Access Compliance Report

Public Rights-of-Way

(Curb Ramps)

Intersection ID: 46488	Main Street: LAUDER_CT	Cross Street: BALLYBAY_DR	Location: SE
ADA ID: C53274B37BD1	Ramp Type: Perp	Initial Pass/Fail: Pass	Overall Compliance: No
Severity Score: 0			
Codes/Mitigation Info/Possible Solution		Field Measurements/Component Compliance

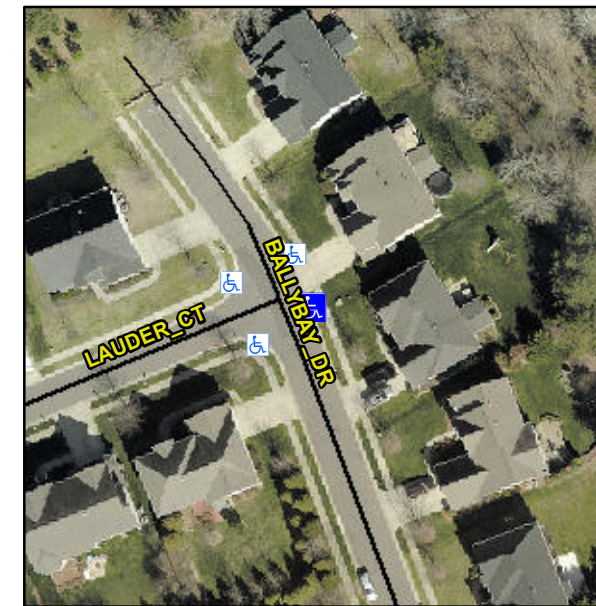
Not Found, R304.2.1

Compliance	Description	Data	Compliance	Description	Data
N/A	Ramp Length (in)	48.0	Yes	Ramp Slope (%)	6.6
Yes	Ramp Width (in)	48.0	Yes	Ramp XSlope (%)	1.1
N/A	Flare Type LT	Sloped	N/A	Flare Type RT	N/A
N/A	Flare Slope LT (%)	2.4	Yes	Flare Slope RT (%)	6.0
N/A	Flare Traversable LT?	Yes	N/A	Flare Traversable RT?	Yes
No	Landing Length (in)	47.0	Yes	DWS Provided?	Yes
Yes	Landing Width (in)	48.0	Yes	DWS Contrast?	Yes
Yes	Landing Slope (%)	1.4	Yes	DWS Length (in)	24.0
Yes	Landing X Slope (%)	0.1	Yes	DWS Full Width?	Yes
N/A	Landing Curb? (Y/N)	No	Yes	DWS Offset (in)	0.0
N/A	Shared Landing?	No			
Yes	Gutter Ponding?	No	Yes	Gutter Slope (%)	0.9
Yes	Gutter Lip Ht (in)	0.0	Yes	Gutter X Slope (%)	1.5
N/A	Painted X Walk1?	No	N/A	Painted X Walk2?	N/A
	X Walk 1 Direction	To SW		X Walk 2 Direction	N/A
N/A	X Walk 1 Width (in)	N/A	N/A	X Walk 2 Width (in)	N/A
	X Walk 1 Slope (%)	4.7		X Walk 2 Slope (%)	N/A
	X Walk 1 X Slope (%)	2.4		X Walk 2 X Slope (%)	N/A

N/A	Ramp inside XWalk1?	N/A	N/A	Ramp inside XWalk2?	N/A
	Road Slope (%)	N/A	N/A	Clear Space?	Yes
	Road X Slope (%)	N/A	N/A	Clear Space to XWalk (in)	N/A
Yes	Any Obstructions?	No	Yes	Storm Grate/Utility Hazard?	No
	Obstruction Type			Storm Grate/Utility Type	
		N/A			N/A
			Yes	Surface Condition? (G/P)	Good

Remove & Replace Entire Ramp.
